# ROYAL RANDWICK RACECOURSE SSD-10285 WINX STAND

Response to request for additional information  
June 2020

Prepared for  
**AUSTRALIAN TURF CLUB**  
18 June 2020

Figure 1 Comparison of the Roof design for the previous and revised design

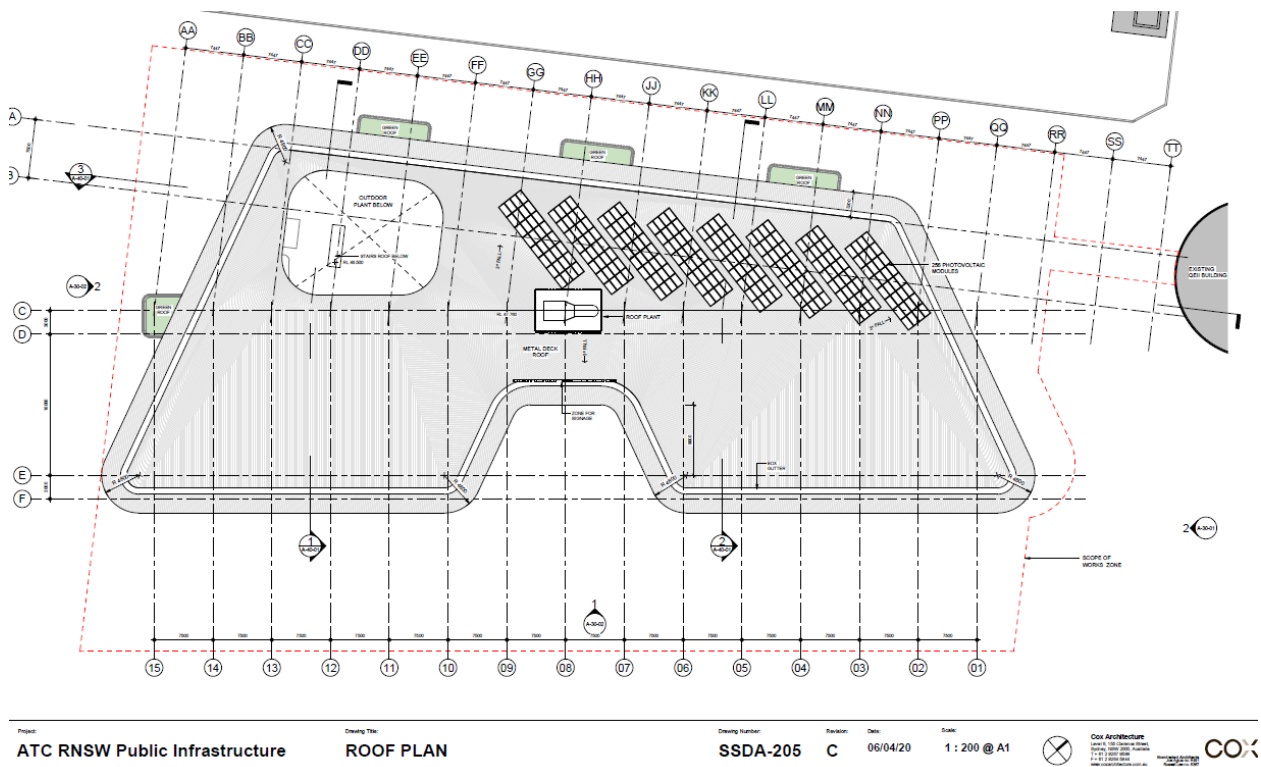
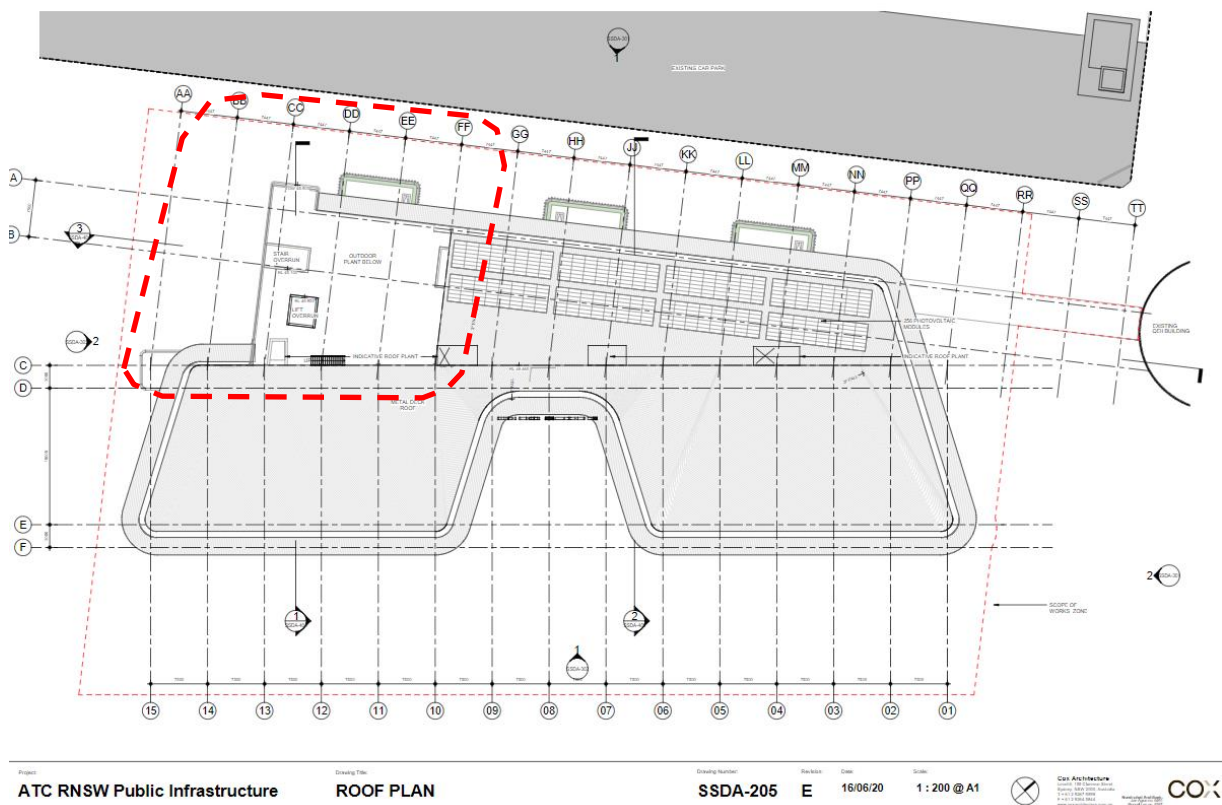
- Roof design amended at the north west corner of the proposal, with a lower roofline for the back-of-house area.
- Tree added to the north west corner, near the proposed loading dock as requested in submissions.
- Clarification on the design of the trackside path/ramp.
- Minor aesthetic design changes to the proposed Winx Stand.
- All plan numbers have been revised as follows:
  - SSDA-001 – D
  - SSDA-102 – D
  - SSDA-201 – E
  - SSDA-202 – D
  - SSDA-203 – D
  - SSDA-204 – D
  - SSDA-205 – E
  - SSDA-301 – D
  - SSDA-302 – D
  - SSDA-401 – D
  - SSDA-701-723 – D
  - SSDA-801 – C
  - SSDA-811 – D

Figure 1 illustrates the proposed amended roof design in comparison to the design submitted with the RtS in April 2020.

Figure 2 Comparison of the previous and revised design of the south elevation

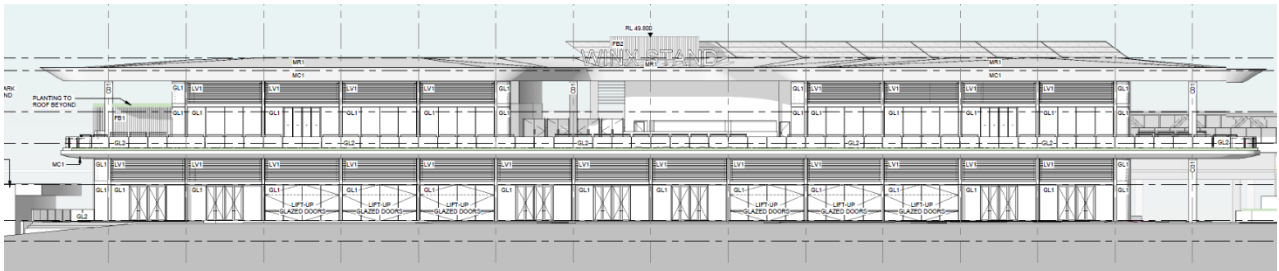
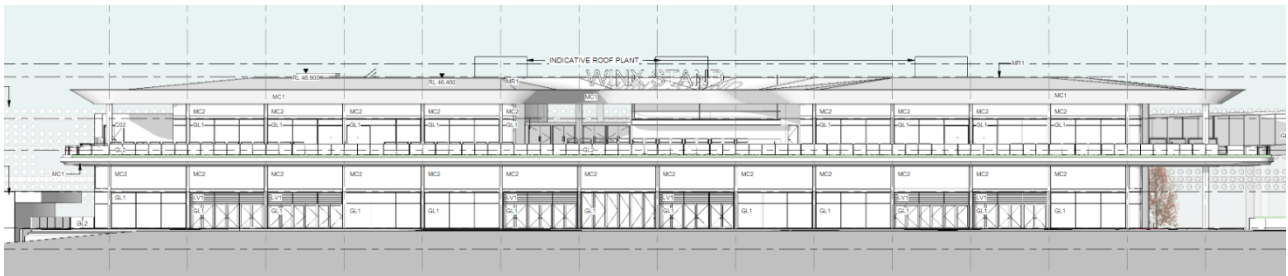
The roof design of the proposal has been amended at the north west corner of the structure, fronting the rear lane. The proposed design changes are to simplify the construction method and provide a more efficient and affordable outcome in response to the current economic climate. Aesthetic changes have also been made in response to comments from GANSW.

Figure 2 illustrates how the roof design changes will result in an outcome that maintains the design elements visible to the public domain, attending patrons and the general public. Proposed changes to the roof design are located at the rear of the proposal and only visible to servicing areas at the back of house not accessible or visible to the public.

Figure 3 Comparison of the previous and revised design of the north elevation

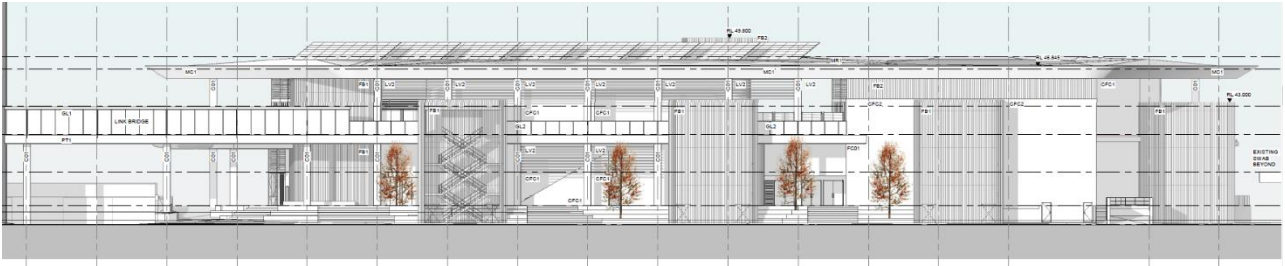
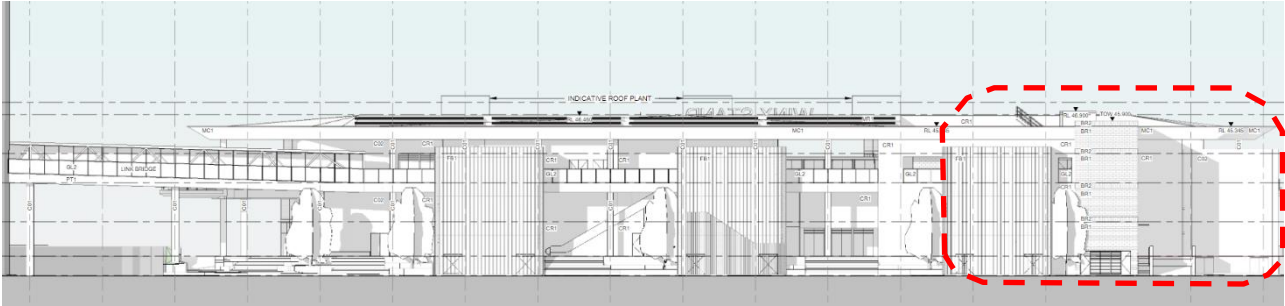
The following Figures 2 - 3 have been provided as a comparison between the original design and the revised design for the north and south elevations. This is supported by Figure 5, which provides a comparison of renders of the north west corner of the proposal for the previous design and the proposed revised design supporting this RFI.

Figure 4 Alternative design review comparing the original design and revised design 2 of 3

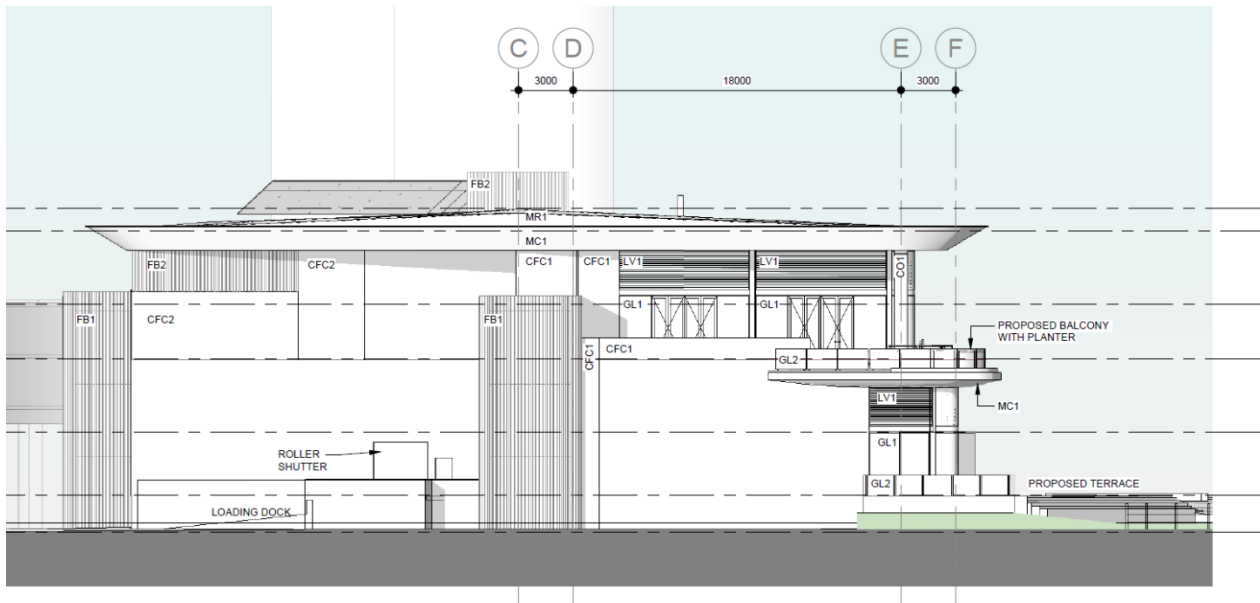
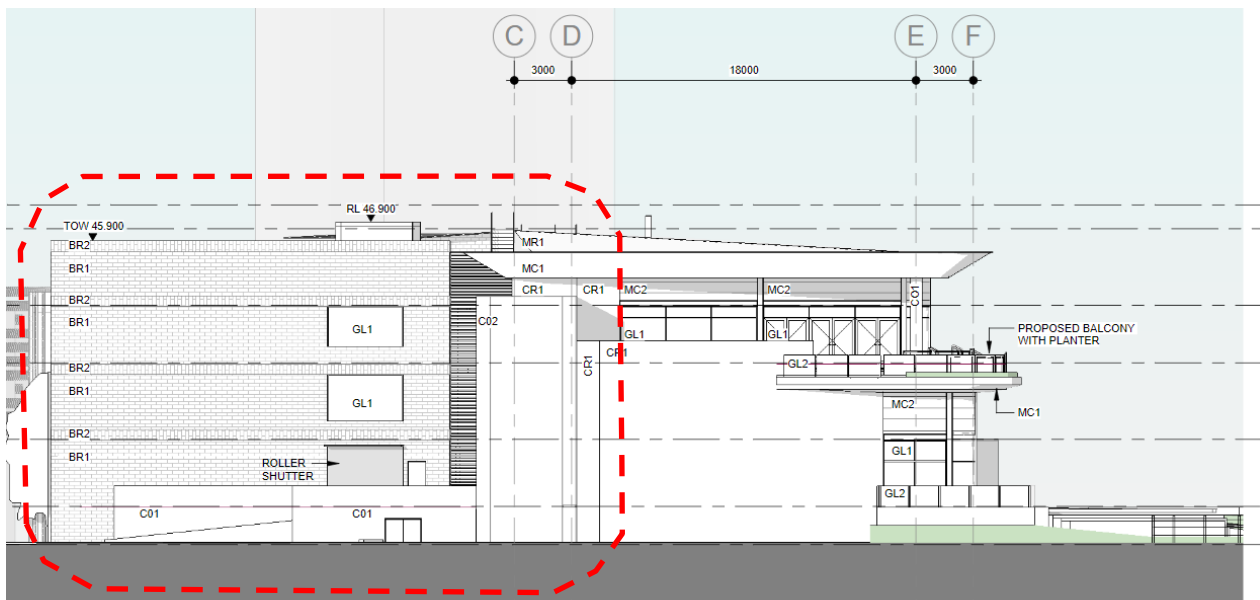
Picture 7 Original design (west elevation from racecourse proper)

Picture 8 Revised design (west elevation from racecourse proper)

Figure 5 North west corner design change comparison

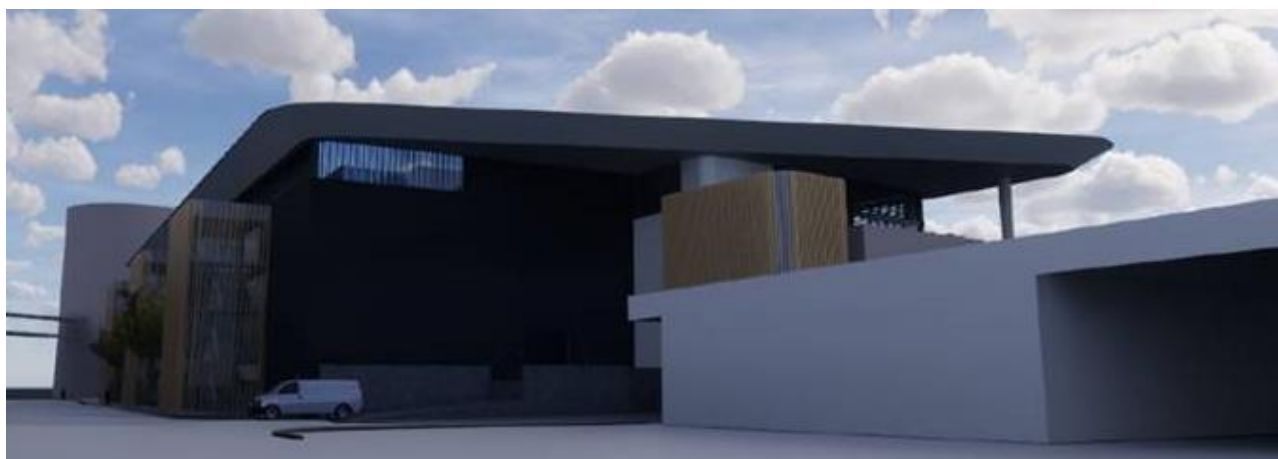
The revised roof design can be seen in Picture 9 from the laneway looking north. The west elevation has been amended to simplify construction of the roof and the internal configuration of the back-of-house area. The southern elevation is now complimented with a brick façade to provide an interesting and attractive aesthetic to the rear laneway and loading dock. The addition of windows on the façade aligned with the lift lobbies on each floor provide improved internal natural lighting and presents the opportunity for, or appearance of passive surveillance in the laneway.

An additional tree has also been included at this corner of the site in response to comments from Randwick City Council and in consultation with, to soften the appearance of the built form.

Figure 6 Royal Randwick Racecourse – Site photos

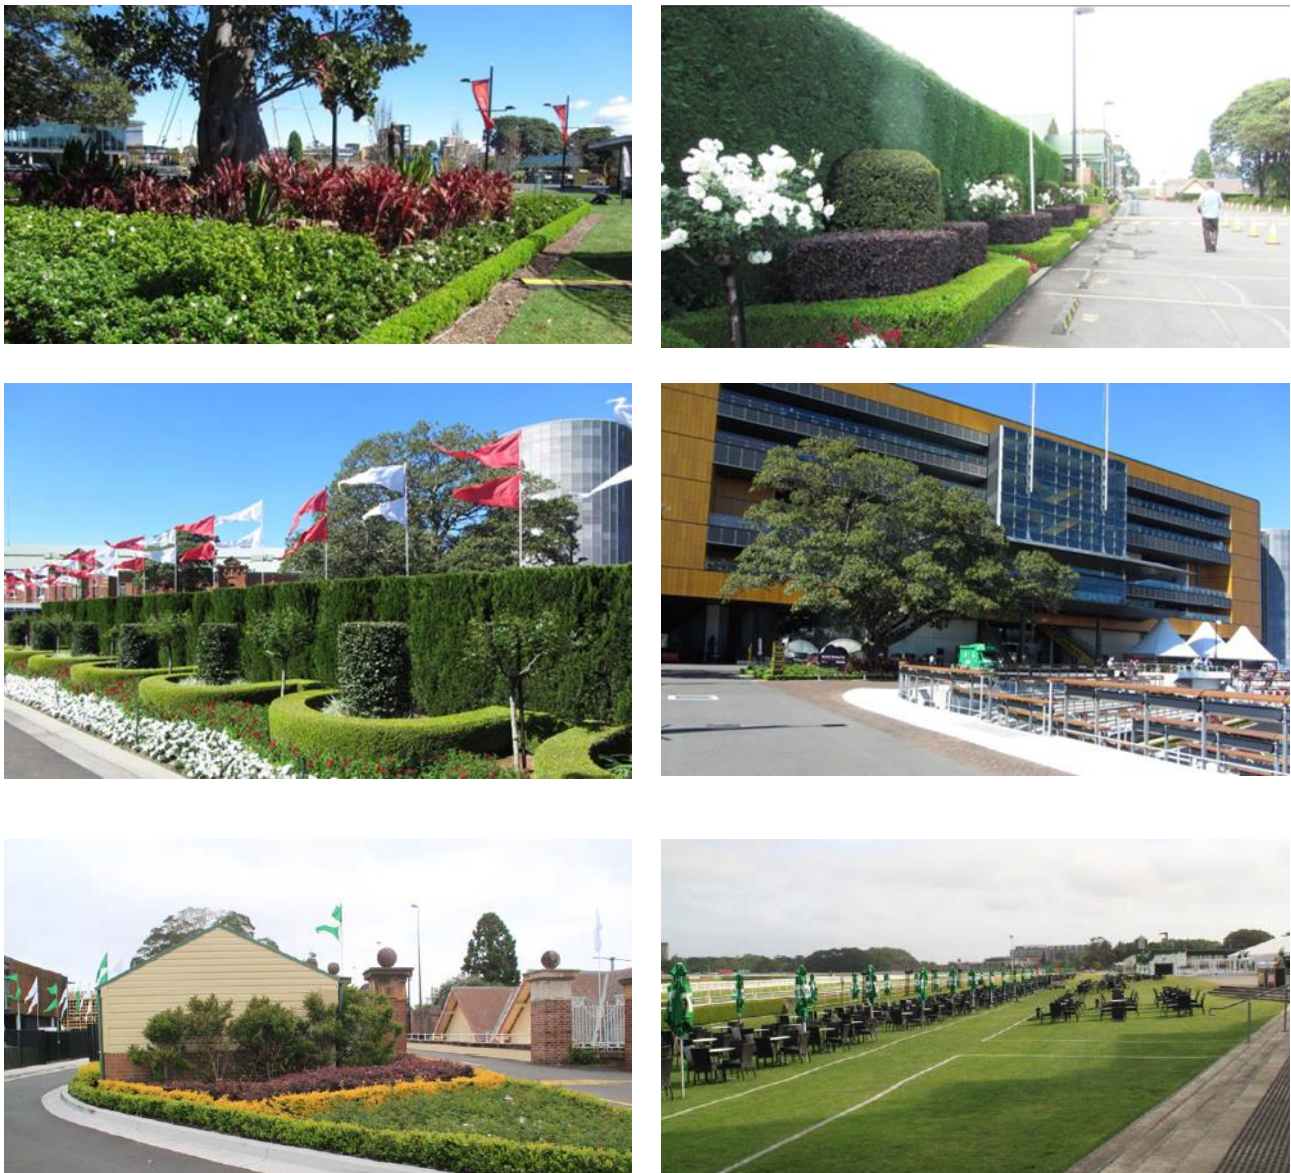
The Winx Stand will be part of the existing Spectators precinct at the Royal Randwick Racecourse. The existing landscape in this area is very distinct and of cultural heritage. Figure 6 shows the existing planting within the Spectators precinct. The planting is very formal and consists of predominately exotic species with tight forms, vibrant colours / floral displays, that are highly manicured into formal planting designs.

EES's suggestions to incorporate native provenance plants into the design are understood. However, the Eastern Suburbs Banksia Scrub and its species completely contrast to the existing Spectators precinct. The use of these species only will not allow the Winx Stand to integrate into the cultural heritage or the broader landscape of the Spectators precinct.

An alternative planting palette for the Winx Stand is proposed that consists of a mix of select species from the Eastern Suburbs Banksia Scrub intermixed with species already used at the site so the proposed landscaping will be in keeping with the Spectators precinct at the Racecourse.
